PLANNING REPORT

Administrative Review Team

Sycamore Ridge Dog Park 23-054MPR

Site Features

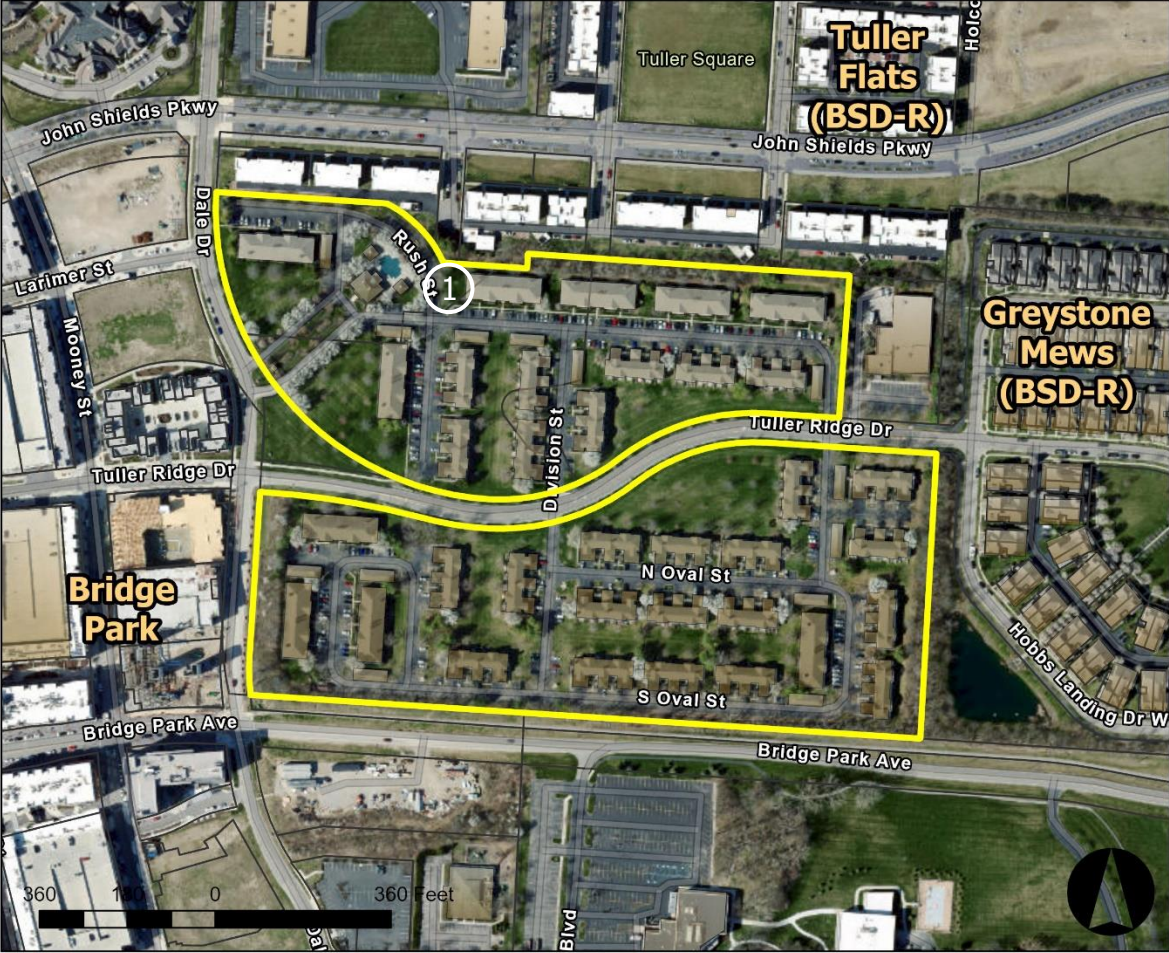
foot wide concrete sidewalk through the center of the park. The applicant is proposing to enclose the dog park with a 4-foot tall galvanized or vinyl coated chain link fence. Chain link is a prohibited fence type within the Bridge Street District. Planning Staff recommends that the dog park fence should match the approved black aluminum fence of the apartment units, previously reviewed by the ART. Additionally, the applicant should work with Engineering to assure that the fence will not impact any existing utilities in the area.

The private park will also be completed with aluminum benches and trash receptacles. The applicant should provide specifications for the benches prior to final site permit approval through Building Standards, subject to Staff approval. The dog park is located adjacent to 7 parking spaces, but no sidewalk is proposed to connect the dog park to the parking. The applicant should provide a sidewalk connection to the parking spaces for pedestrian circulation.

- 1) The dog park fence match the approved black aluminum fence of the apartment units, previous reviewed by the ART;
- 2) The applicant work with Engineering to assure that the fence will not impact any existing utilities in the area;
- 3) The applicant provide specifications for the benches prior to final site permit approval through Building Standards, subject to Staff approval; and,
- 4) The applicant provide a sidewalk connection to the parking spaces for pedestrian circulation.
